VILLAGE OF CALEDONIA UTILITY DISTRICT MEETING AGENDA

Wednesday, May 5, 2021 at 6:00 p.m.
Caledonia Village Hall - 5043 Chester Lane

RE: DeBack Farms Pad F – Scannell Properties LLC – Storm Water Management Plan & Utility Plan Conditional Approval

SHEET C-5
C-22

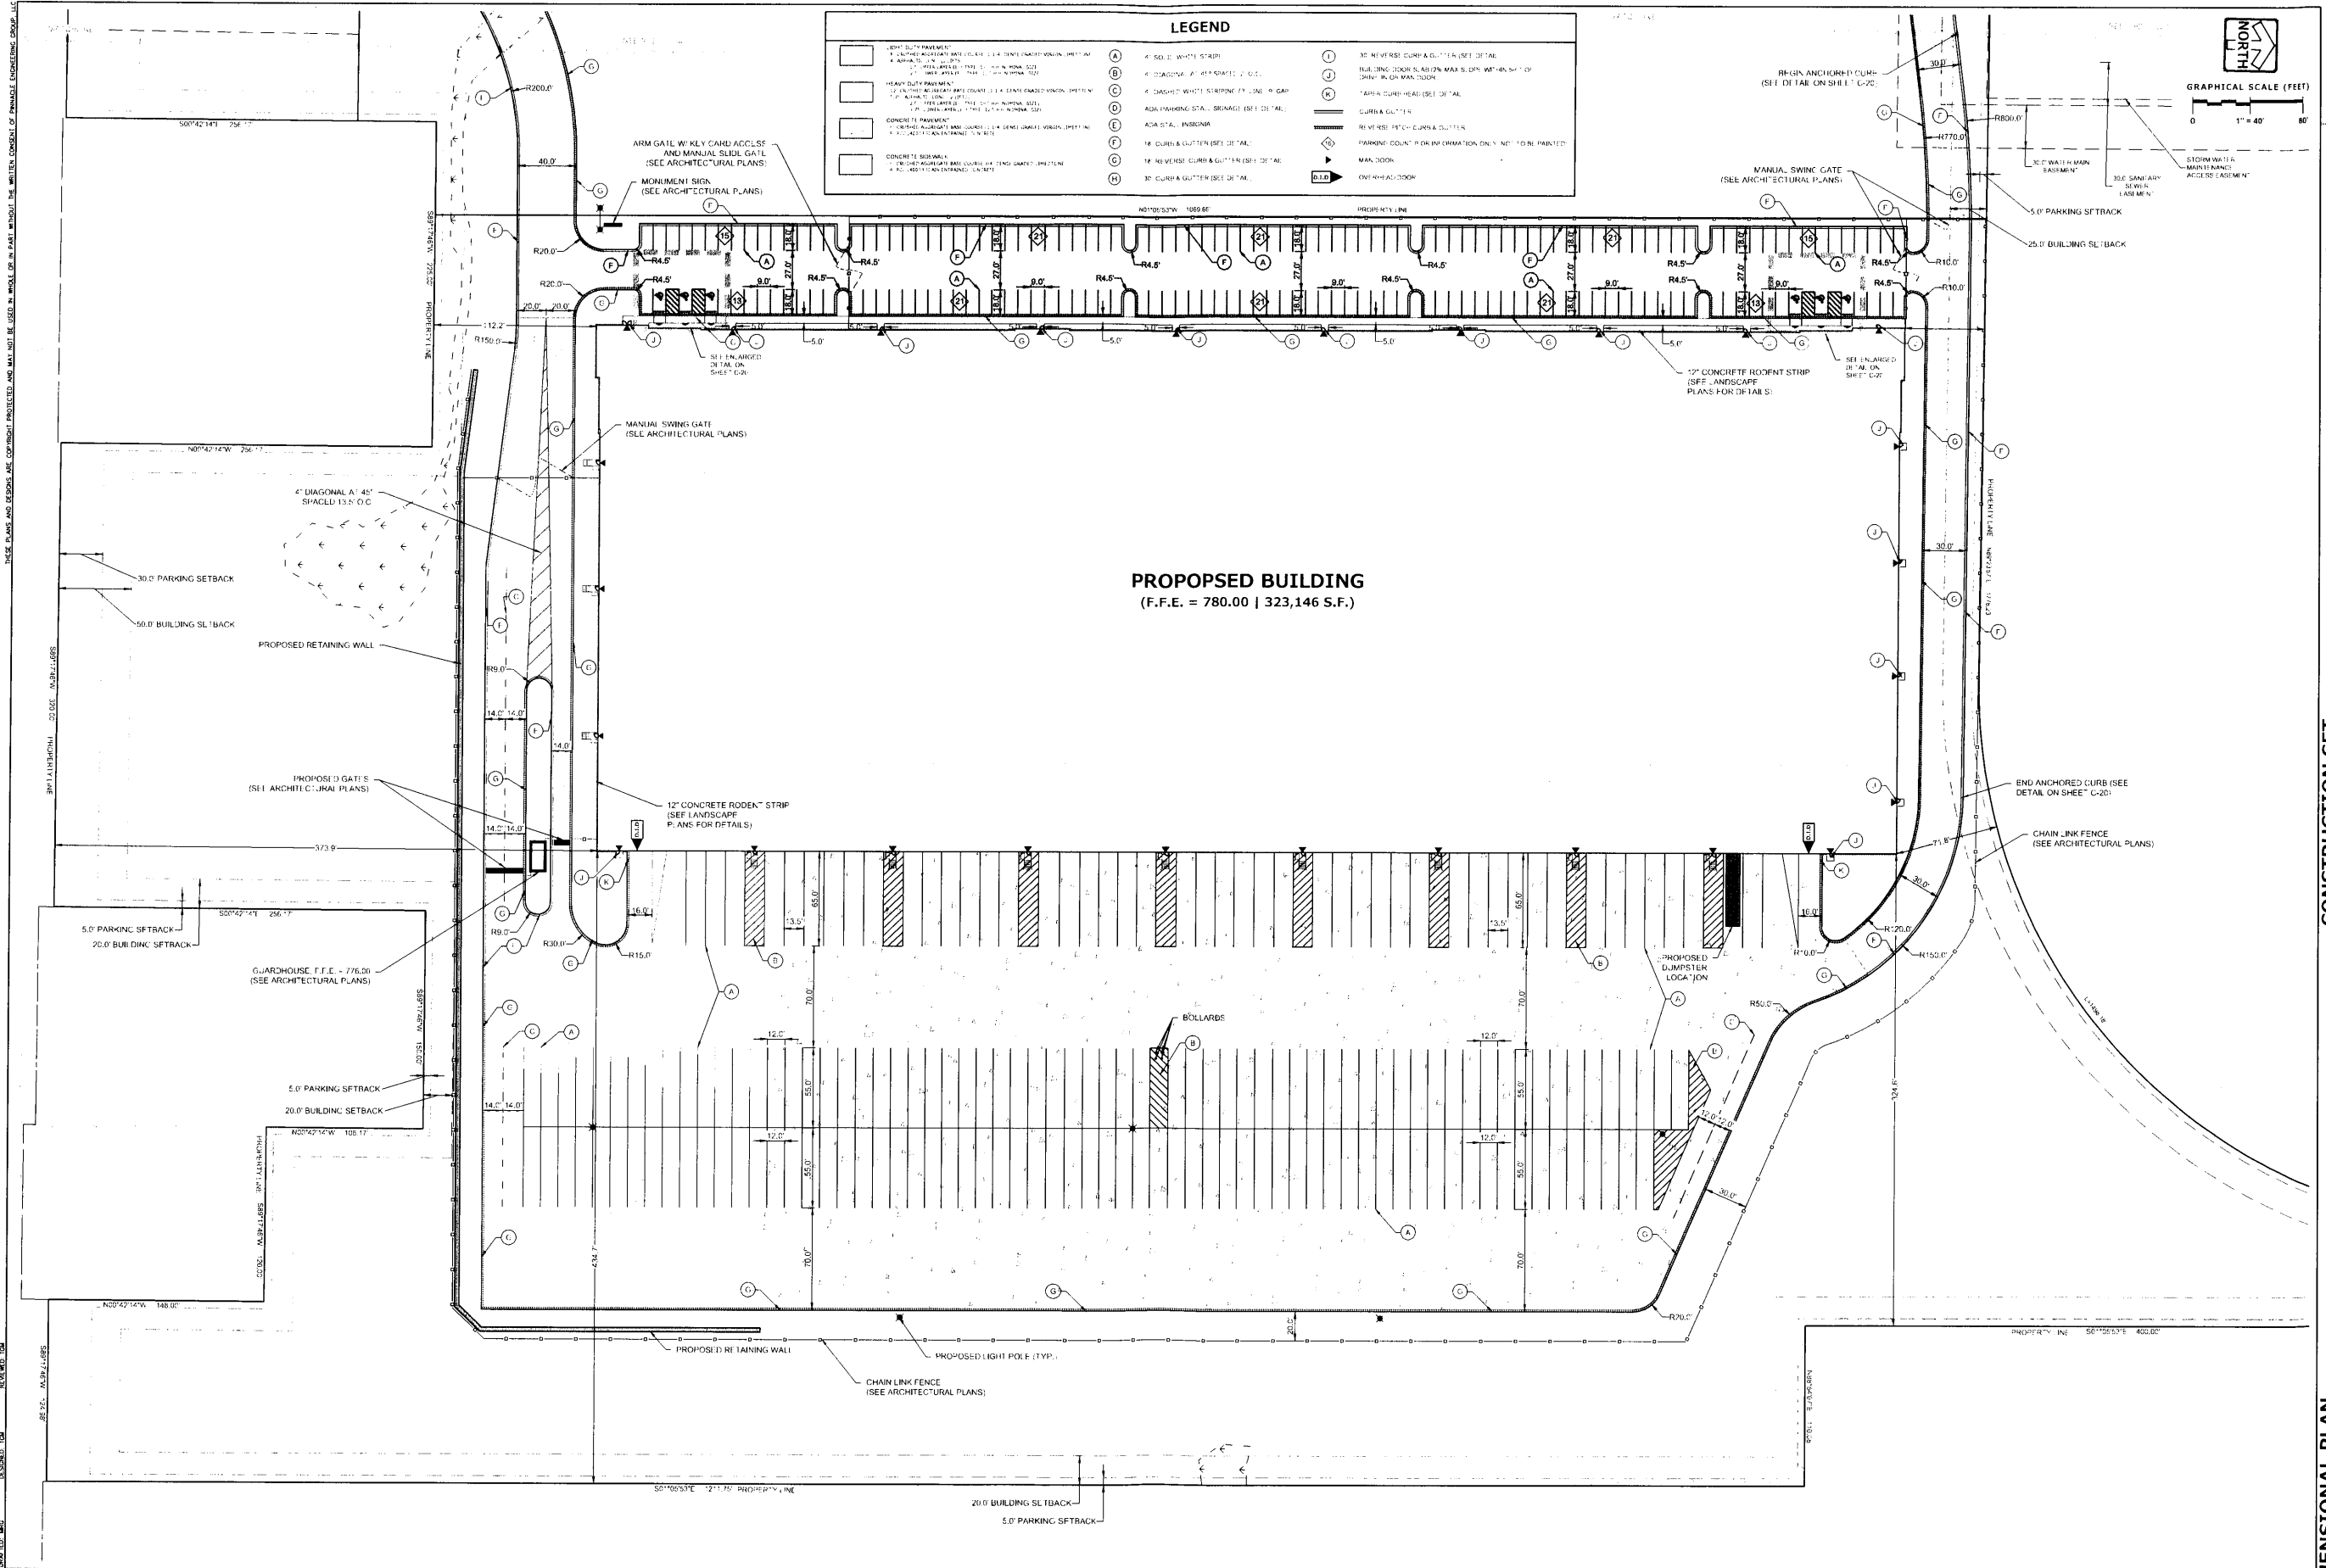
Sheet C-5

**SHEET
C-8
C-22**

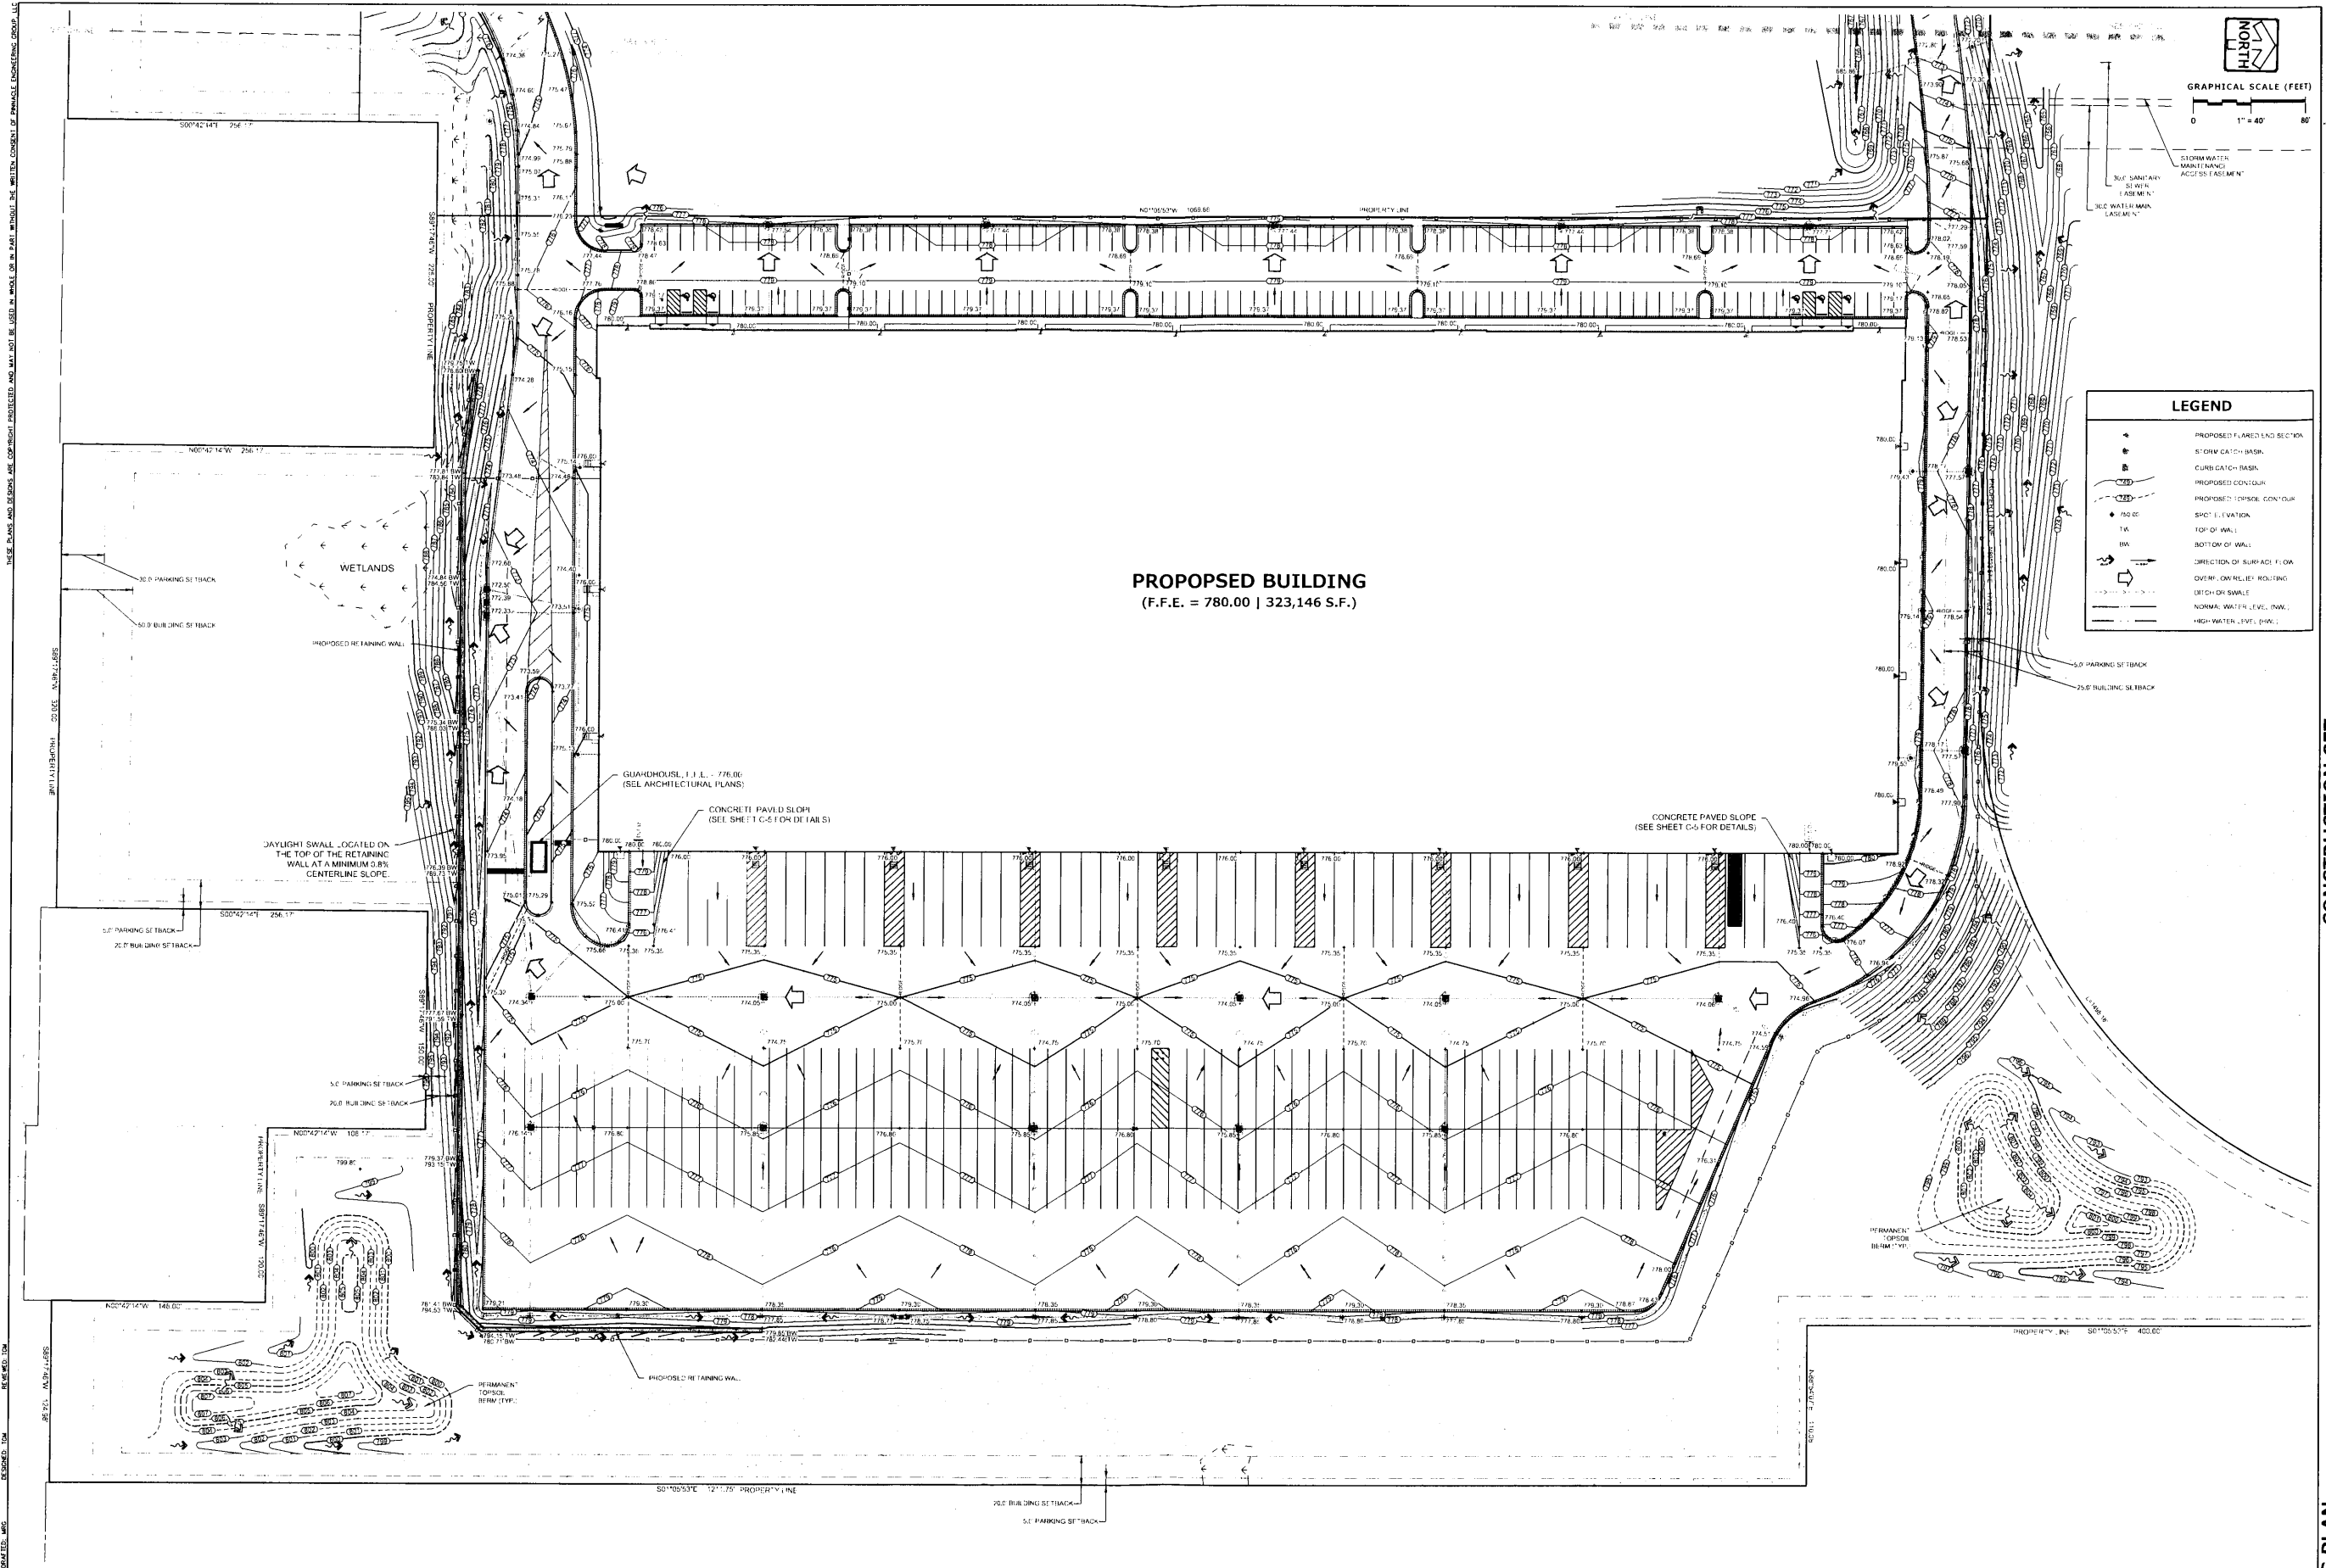
Sheet C-8

3. At the north and south DID loading ramps, will need to taper down 4' from 780 to 796.0 with side slopes not to exceed 4:1. *Will need to cross hatch or place a note that the slopes are paved.*
